## Technical Service Bulletin

**Subject:** Error 03

**Models Affected:** Convertamatics (All), Warriors (All), BA 755 series (All)

**ECO#:** A- 03072

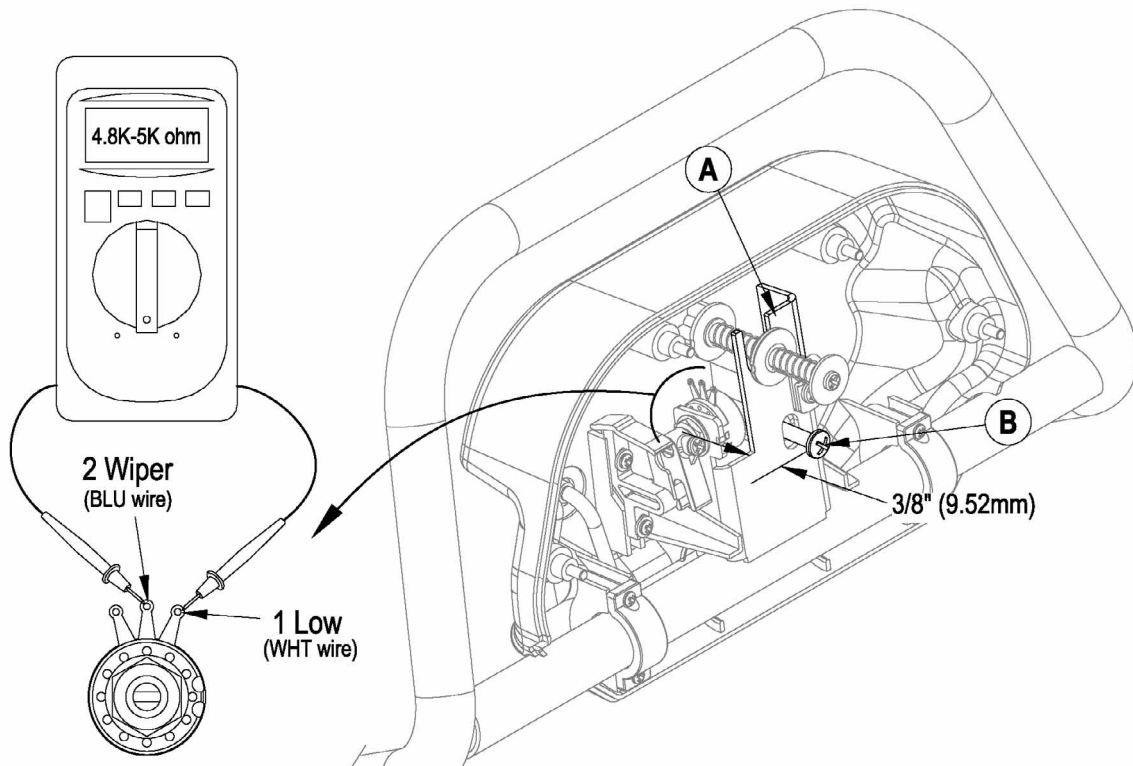
**Issue:** The bracket (A) on the paddle handle weldment can bend if excessive forward pressure is applied to the handle paddle. This in turn can cause a speed controller error "03".

**Corrective Action in Production:** The speed controller has been programmed with a wider dead band setting for neutral and the thickness of the handle bracket (A) has been increased to prevent bending. Also the range of forward motion of the handle has been reduced by changing the stop screw (B) at its maximum speed setting (see illustration below).

**Corrective Action for in the Field:** Re-adjust the 5k potentiometer to its neutral position (refer to service manuals 56043098 or 56043103). Then turn the screw (B) in until the distance between the underside of the screw head and the bracket is 3/8" (9.5mm). This will cause the screw head to contact the bracket when excessive force is used and prevent the handle paddle from over traveling potentiometers limit. After adjusting the screw connect an Ohm meter to the 1 Low and the 2 Wiper terminals of the potentiometer. Push the paddle forward until the screw head contacts the bracket. Check the reading on the Ohm meter to make sure it is reading between 4.8k to 5k ohms. If less than this, turn the screw back out until the resistance reading is between these 2 values.
